September 24, 1984

Joseph M. Farley Nuclear Plant - Units 1 and 2
Proposed Administrative Technical Specification Change

Figure 6.2-2 Facility Organization

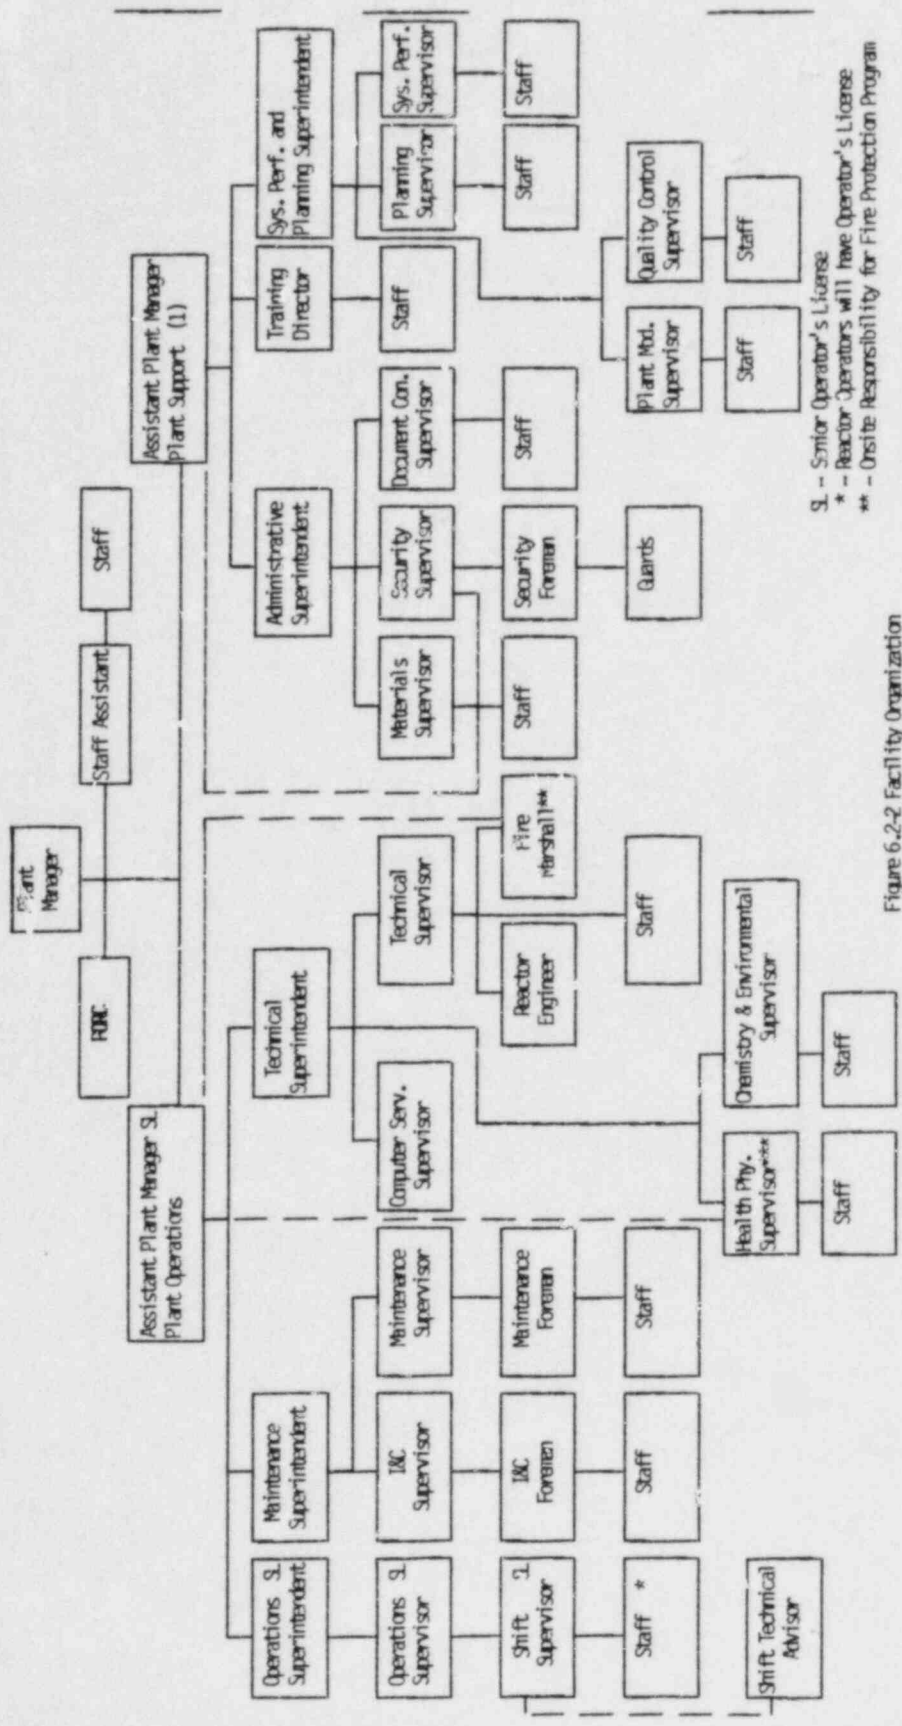
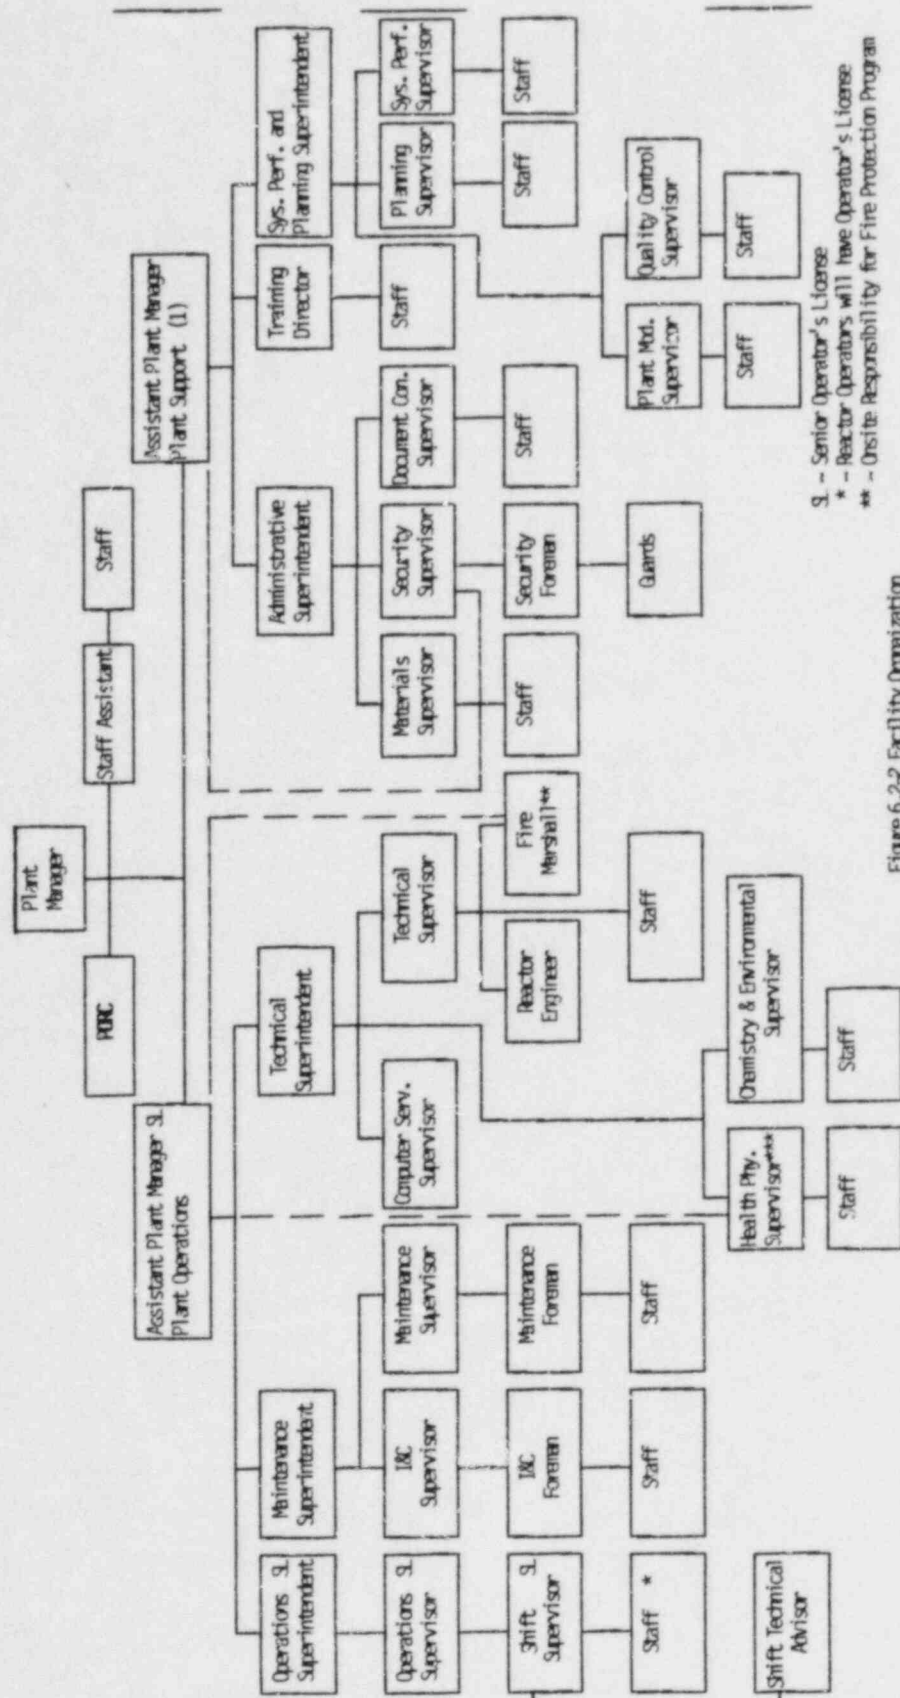
The Assistant Plant Manager, Plant Support position has been established with the recognition that in the absence of the Plant Manager, the Assistant Plant Manager, Plant Support may occasionally be delegated the Plant Manager's responsibilities. This means that prior to being delegated these responsibilities, the Assistant Plant Manager, Plant Support will be fully qualified to fulfill the responsibilities of the Plant Manager per ANSI N18.1-1971 and FSAR 13.1.3.1.1 with the added stipulation that Emergency Director Training has been completed.

Attached is revised Technical Specification Figure 6.2-2 for Units 1 and 2 to reflect the above clarification. This clarification is a non-substantive change to the June 25, 1984 proposed technical specification change. The necessary changes to the FSAR have been initiated, pursuant to 10CFR50.59, to reflect the proposed technical specification change and this clarification. The appropriate procedures will be modified to indicate this clarification of operation responsibilities after receipt of the approved license amendment.

(1) The person filling this position may act as the Plant Manager, provided this person meets the requirements of ANSI N18.1-1971 Section 4.2.1, FSAR Section 13.1.3.1.1 and has completed Emergency Director Training.
